HDC-2023-00029

Address: 246 N. 11th Street

Proposal: Replace vinyl fence with wood fence (violation correction)

Historical Architectural Review Board COA Final Review Sheet

Vinyl fence installed without permits. (HARB files)

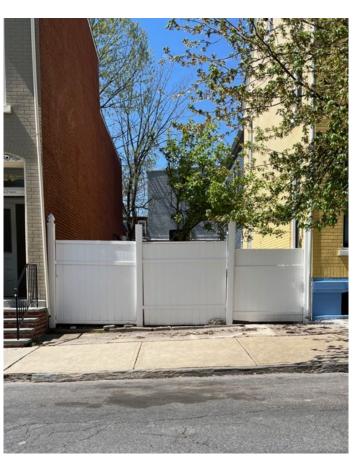
The previously installed wood privacy fence had been in place behind the historic wrought iron fence for approximately ten years. The 2014 photo shows both fences, and staff notes that a large section of the wrought iron fencing was missing at that time. While the design guidelines advocate for in-kind replacement of historic fences, they also allow for wood shadow box or picket fences, provided primary or highly visible facades are not obscured. In this case, the fence encloses a side yard and does not significantly impact the building's facades. Staff finds the proposed wood privacy fence to be acceptable, provided it is painted, since much of the historic wrought iron fence has been missing for approximately ten years.

The HARB recommended following the guidelines as closely as possible and suggested changing the vinyl fence to either a picket fence or shadow box fence. The HARB discussed the proposed wood stockade fence and agreed it would be acceptable with the pointed ends either placed in the ground or squared off at the top. The HARB agreed that the fence should be painted to meet the guidelines.

Approval, provided the fence is painted and with the staff to review details, pursuant to Chapter 3, Section 3.12 Fences & Streetscape Features.

Mr. Lichtenwalner moved to approve the application presented on 7/10/2023 for the installation of a wood fence at 246 N. 11th Street, with the staff to review details, provided the fence is painted and top is squared off, pursuant to Chapter 3, Section 3.12 Fences & Streetscape Features. Mr. Encelewski seconded the motion, which carried with unanimous support.
